City of Austin

Site Plan Application – Master Comment Report

Case Number: SP-2026-0136C

Project Name: 1700 South Lamar

TPW 9: Comment Status:

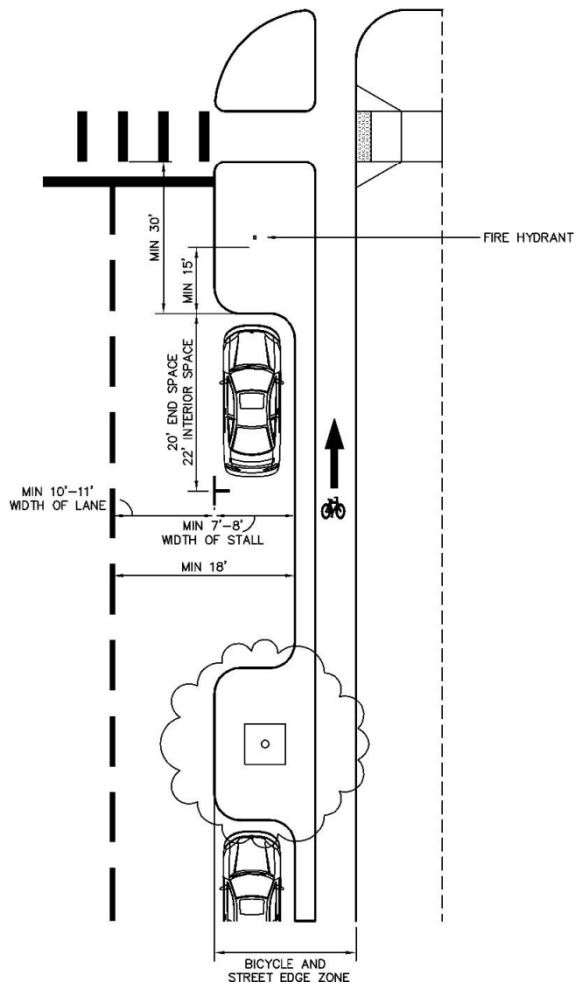
- Parking bulb-outs must adhere to standard design (see below).
Reference: TCM Fig. 9-2, 9.2.3.1

TPW 10: Comment Status:

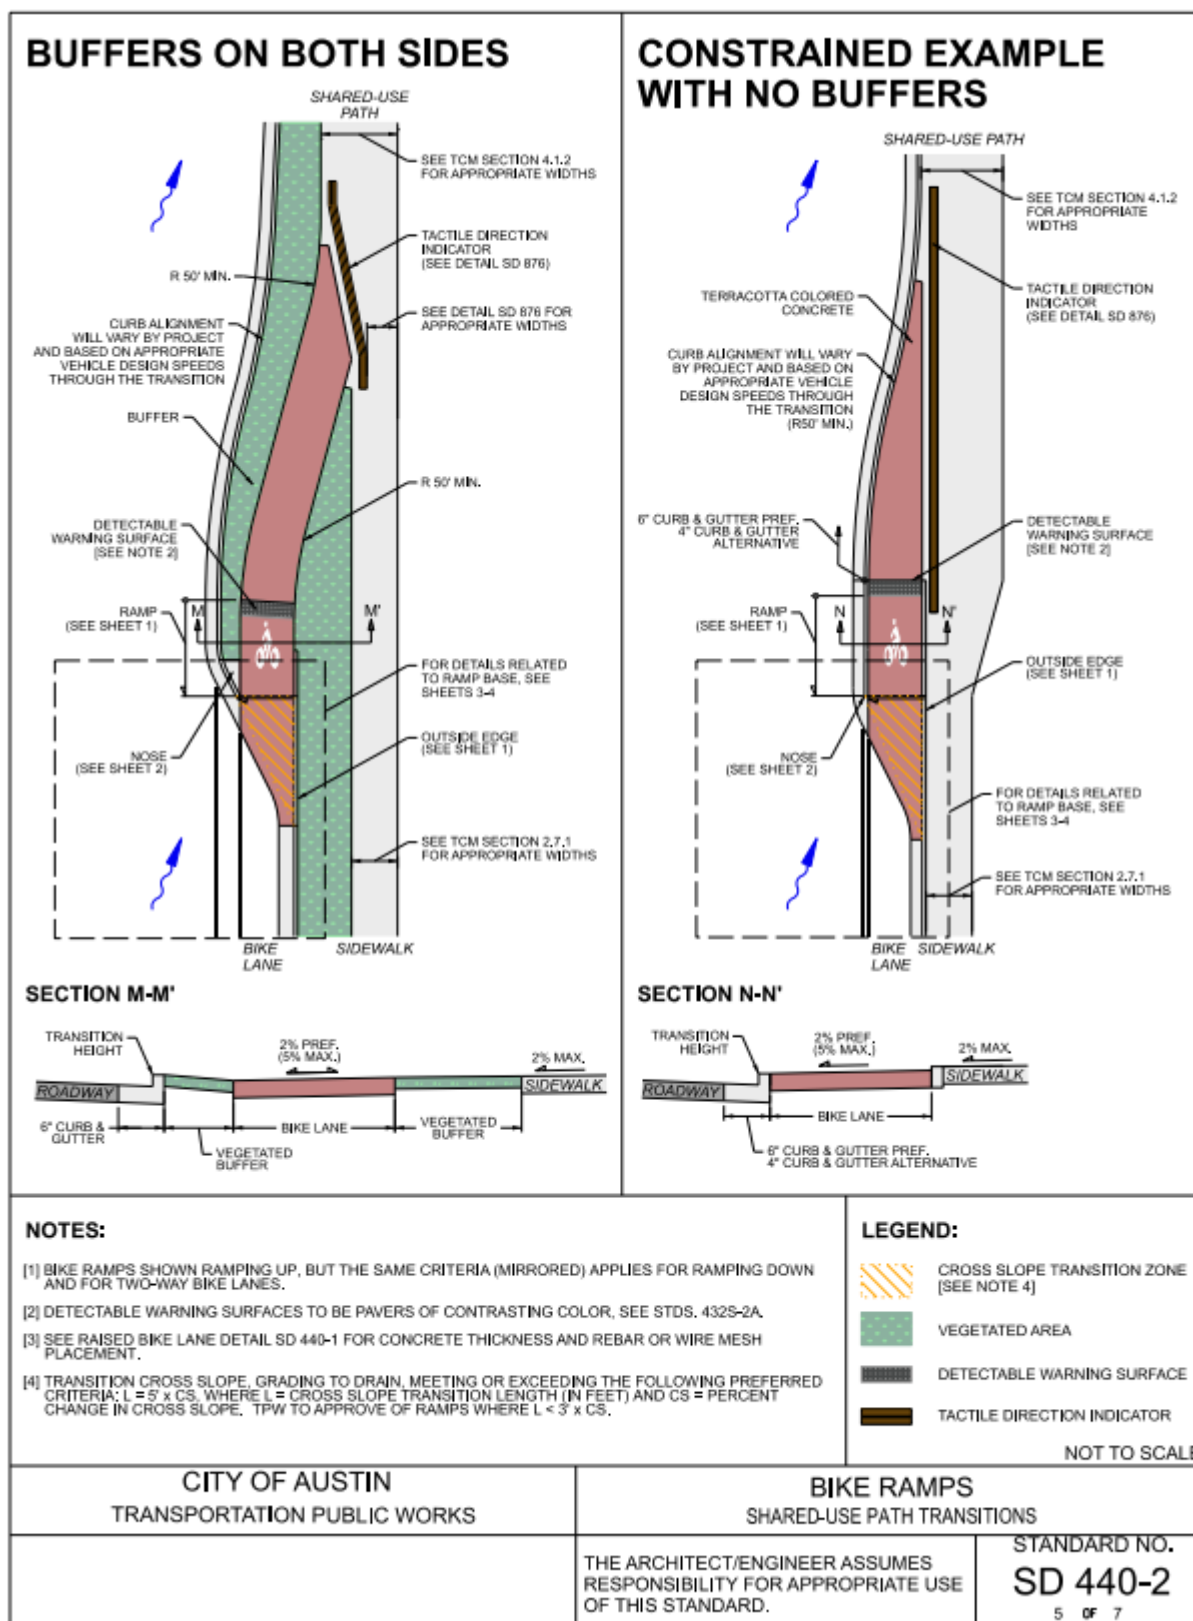
- Use one of the standards from SD 440-2 for bike lane transition from Collier Street to protected intersection. *Tactile indicators, directional markings and warning surfaces are needed. Where bike ramp and sidewalk merge, scramble area should be 8' min.*
Reference: TCM 5.2.0.

TPW 12: Comment Status:

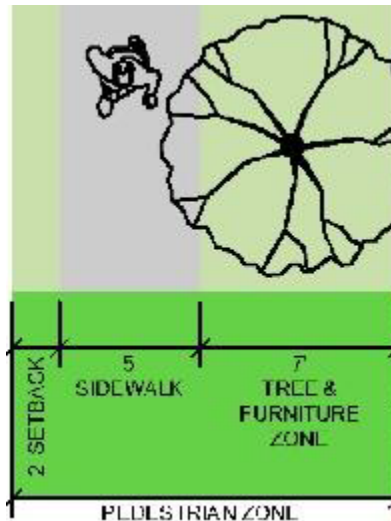
Collier Streetscape: A 7' tree and furniture (planting) zone, measured from the back of curb is required. *Street trees placed 30' on center are required.* A license agreement may be required. This is to be followed by a 5' minimum clear zone (sidewalk) and a min. 2' buffer zone between the building/property line. *TCM 2.8.2.2*

TPW 15: Comment Status:

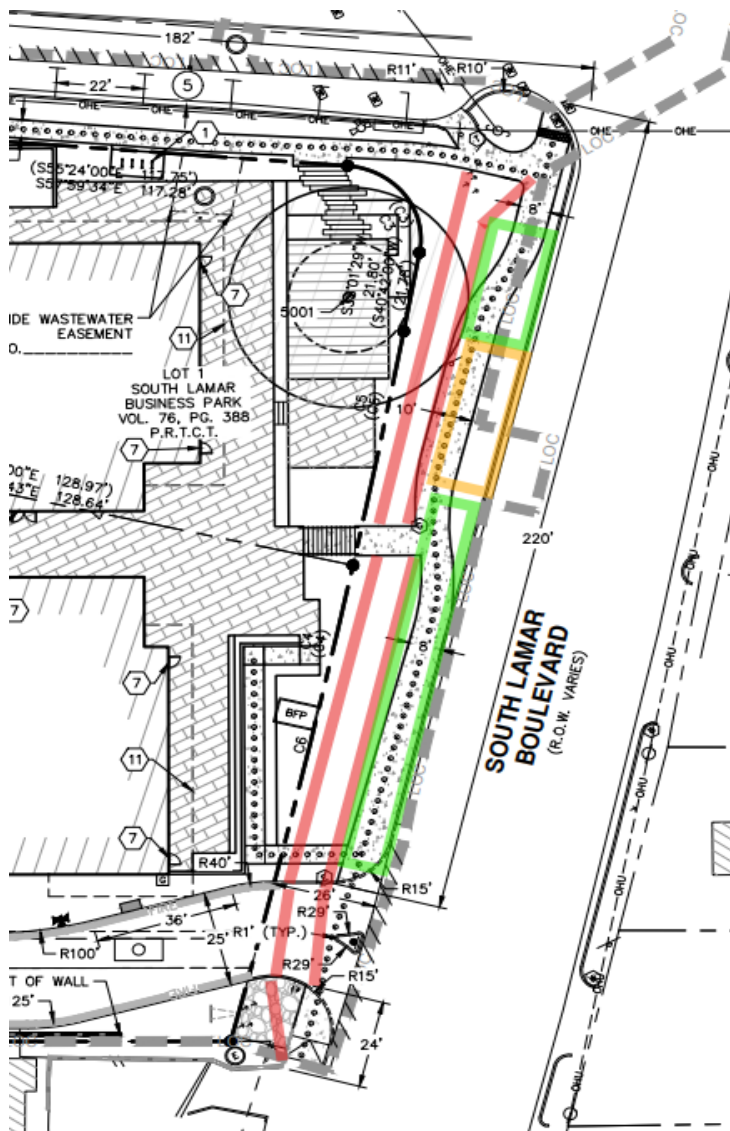
- When pedestrian and bicycle facilities are combined into a shared use path, the shared use path shall be located between the right-of-way line and Tree & Furniture Zone unless placement in an easement is approved by applicable staff.

- A SUP configuration will be allowed (with waiver) if planted tree zone is located back-of-curb; roughly following this alignment:*

SHARED-USE PATH BEHIND BUS LANDING AREA

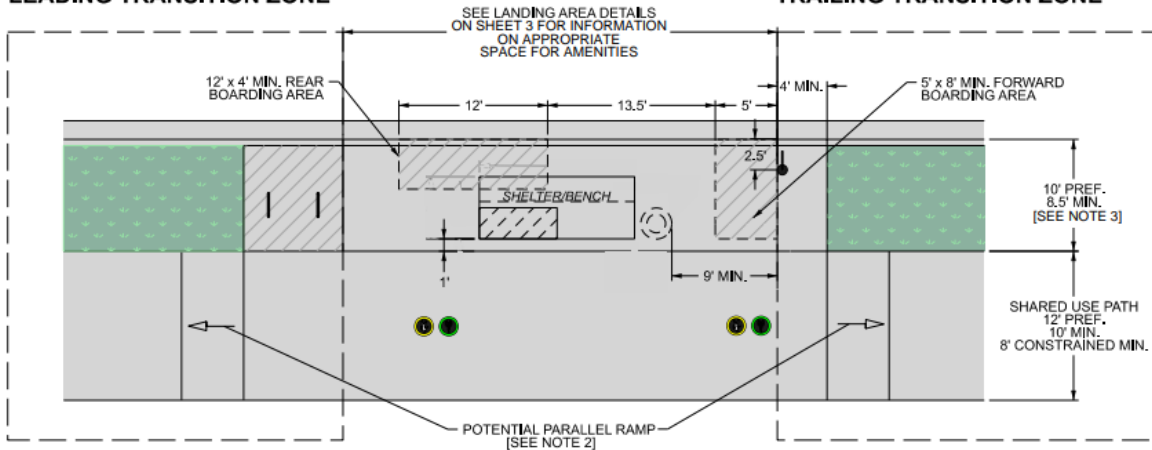
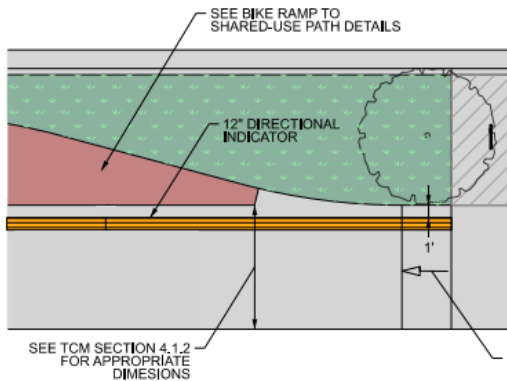
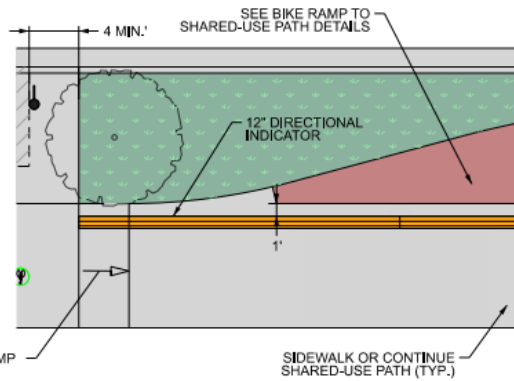
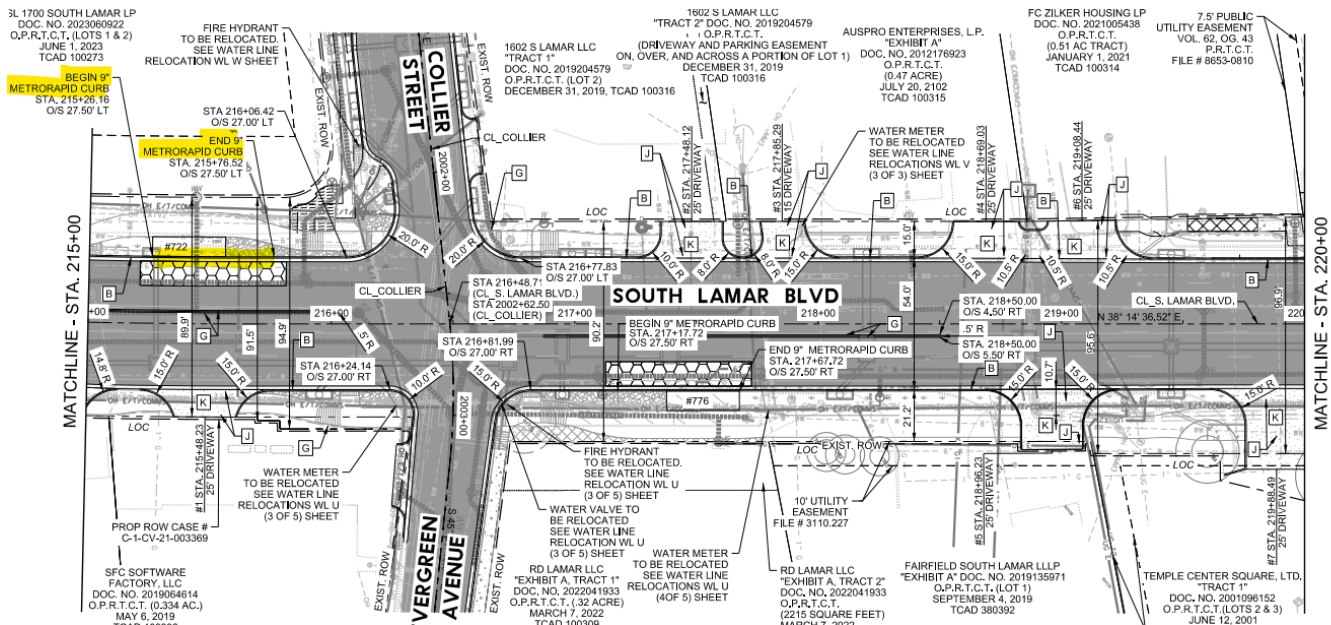
For future bus stop, please use the shared use path detail:

- Note planned curb height is 9" for the bus stop pad per corridor improvements plans:

RIGHT-IN / RIGHT-OUT ISLANDS AT DRIVEWAYS

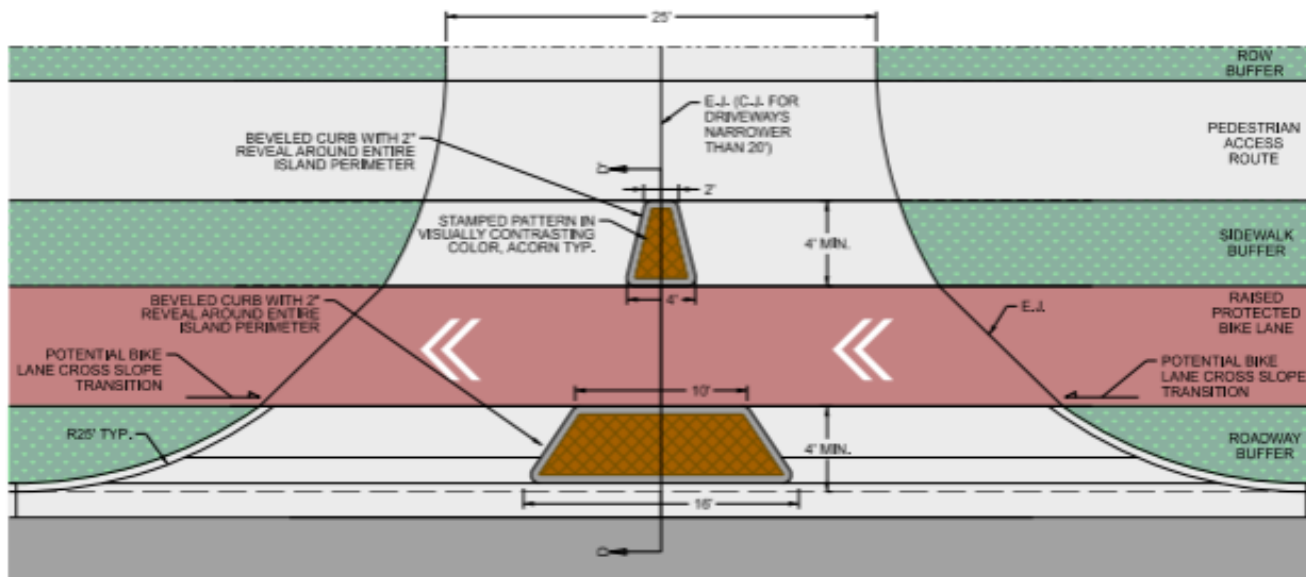
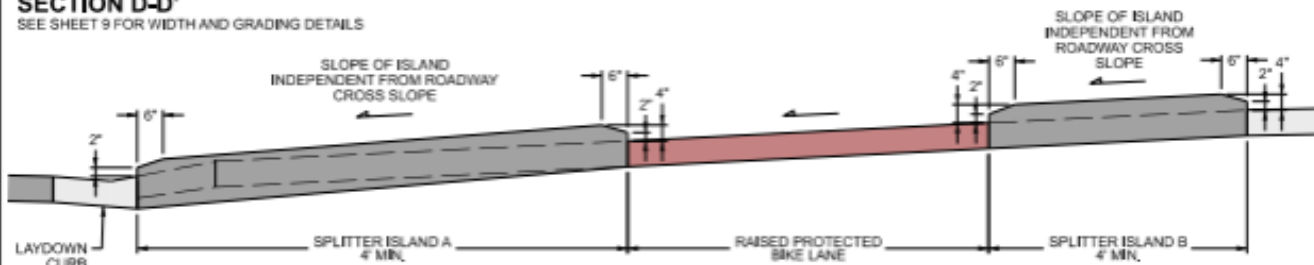
- Driveways must be separated from adjacent driveways by at least 200 feet (S. Lamar).
Reference: TCM, Table 7-5

- On Level 3 or higher roadways, left turns exiting driveways are prohibited without a signal or protected operation.
Reference: TCM, 7.3.0
- A waiver may be requested and will be approved if the driveway is right-in, right-out only and adheres to the standard detail (shown below). <https://atd.knack.com/development-services#customer-portal/services/tpw-waiver/>. Please note a waiver review fee will be assessed.
- Note the direction of flow on the site plan and show locations of "one-way" and "do not enter" signs.
Reference: TCM, 9.3.4.2.H and Fig. 9-12

DE 7 – Current Status: Pending

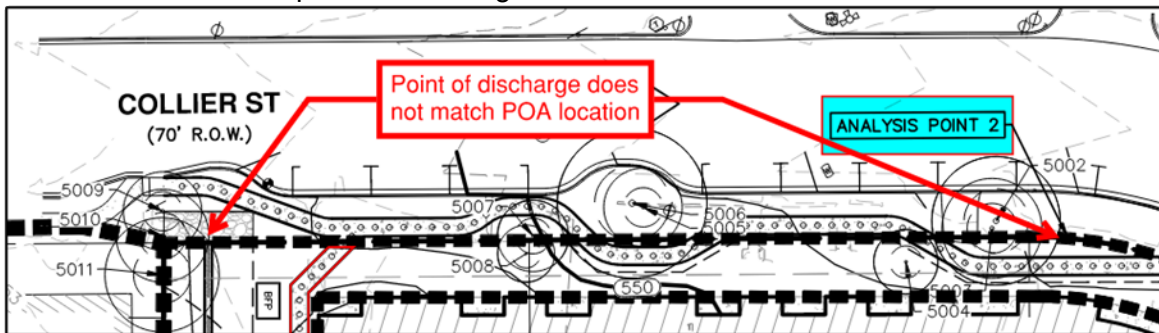
- U0: Based on the proposed drainage area map provided on sheet 24, the location of Analysis Point 2 does match the actual point of discharge from the site.

DE 22 – Current Status: Pending

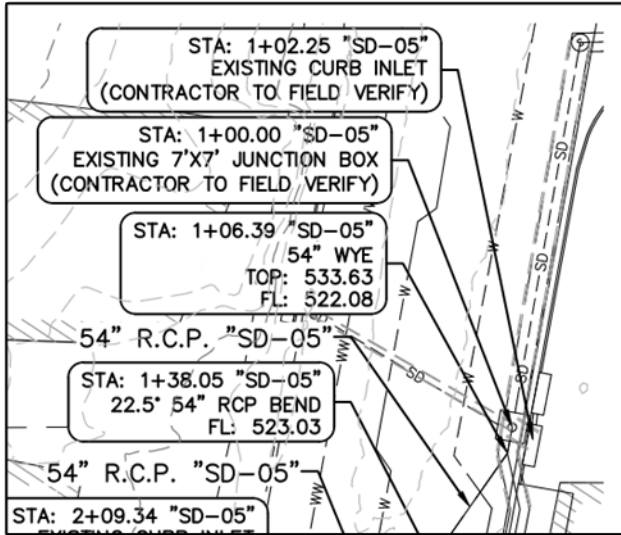
- U0: Please provide more information in the plans to clarify the proposed configuration of the connection into the existing storm system within South Lamar Boulevard. The proposed wye in this location does not appear to be code compliant.

DE 23 – Current Status: Pending

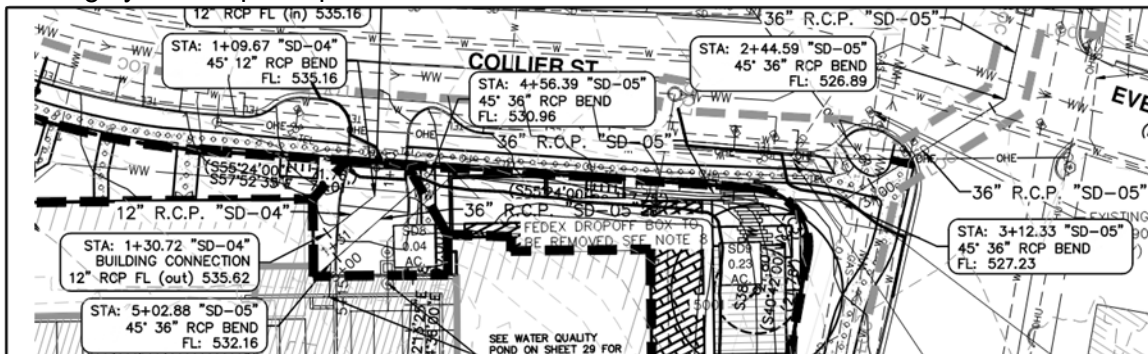
- U0: Please clean up and layer control the storm drain layout sheets, specifically the plan view for SD-04 and SD-05 on sheet 28. The current plants are congested, difficult to interpret, and the location of the proposed storm lines are not visible/legible in the plan view. Engineer of record is encouraged to thoroughly QA/QC plans prior to resubmittal.

DE 30 – Current Status: Pending

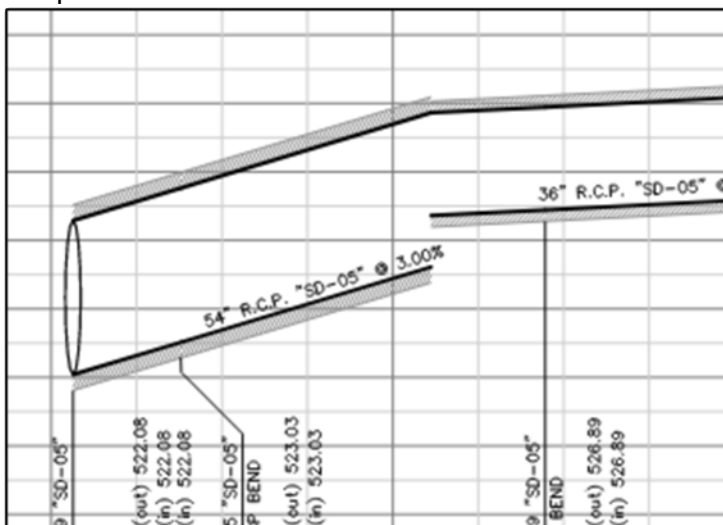
- U0: A manhole shall be placed at locations where changes in pipe size occur. Please demonstrate compliance.

DE 31 – Current Status: Pending

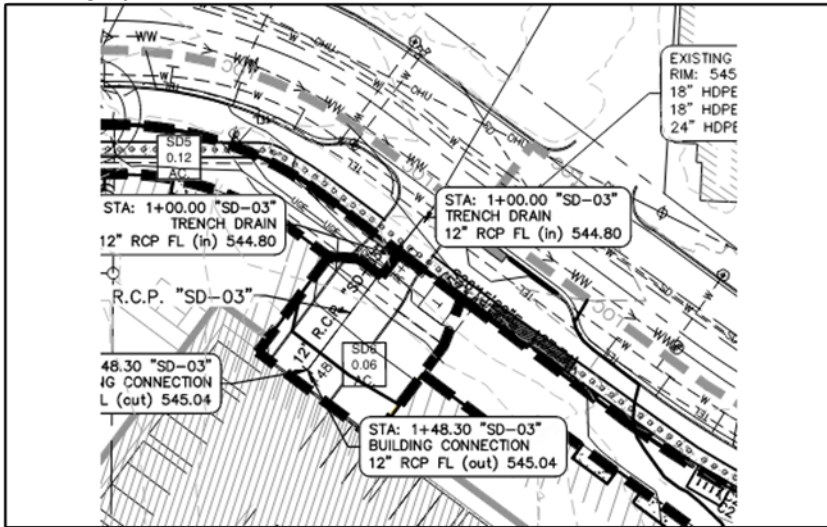
- U0: There appears to be multiple instances of redundant call outs and viewport cutoffs throughout the plans which make it difficult to interpret the intended design. Engineer of record is encouraged to thoroughly QA/QC plans prior to resubmittal.

Update #0
Rejected

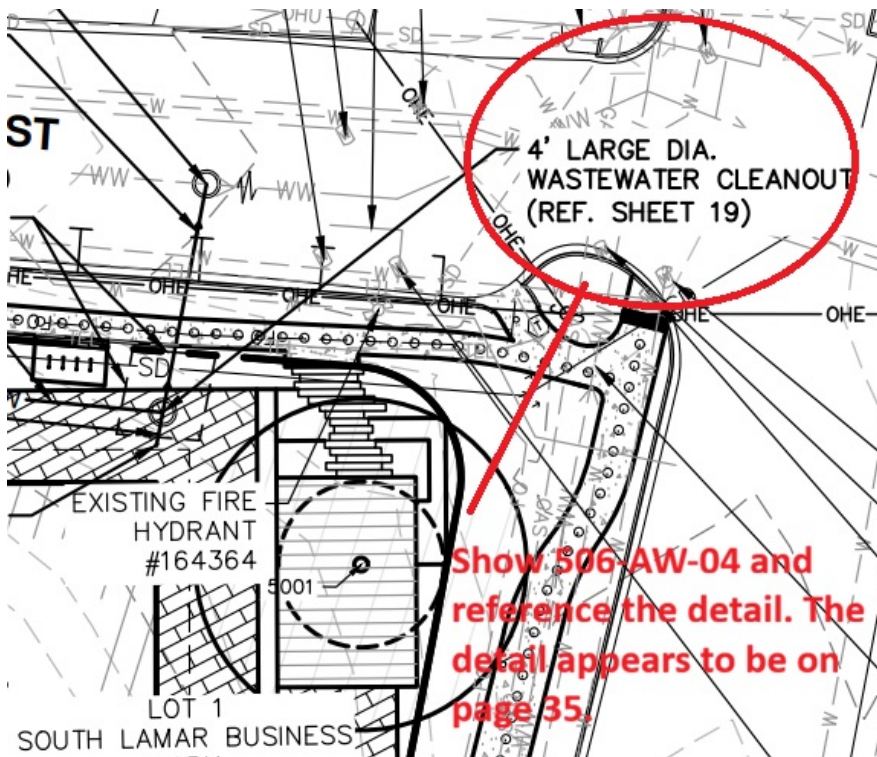
- **U0: If WW lateral = $8'' \leq \phi \leq 12''$:**
For compliance with §15-10-226 of the Austin City Code and UCM 2.9.4.G.5, install a City of Austin approved **large diameter cleanout** per Standard Detail 506-AW-04 to act as a sampling and inspection port. Reference the detail in the call-out and include the detail in the utility detail sheets. Per UCM 2.9.4.G.7, the cleanout must be located at or near the property line within the public right-of-way (ROW) or utility easement line. The cleanout **shall not** be located in a vehicle traffic area, parking area, load bearing pavement, sidewalk, or driveway. Be aware there is a 14' foot depth limit for the large diameter cleanout structure.

SP47 - Current Status: Pending

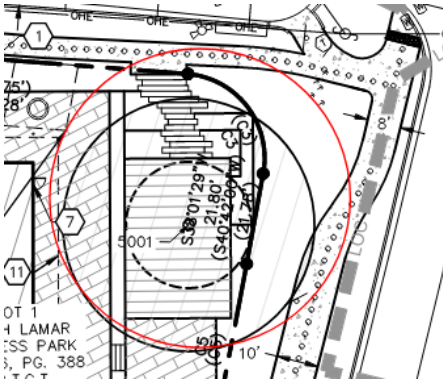
U0: Review the Site Plan Sheets to ensure that all development is identified with callouts or in the Legend. Specifically, identify the features shown below. If the area shown consists of stairs and a raised deck, or similar structure, please include those features on the Elevation Sheets as appropriate.

SP50 - Current Status: Pending

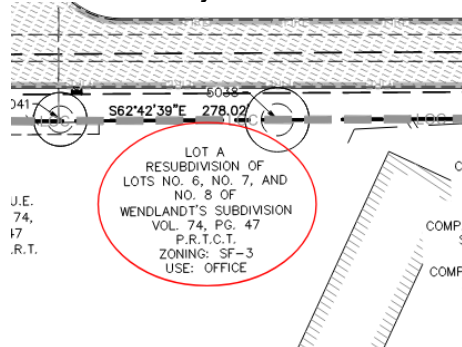
U0: Correct the adjacent use to the west of the site from Office to Religious Assembly.
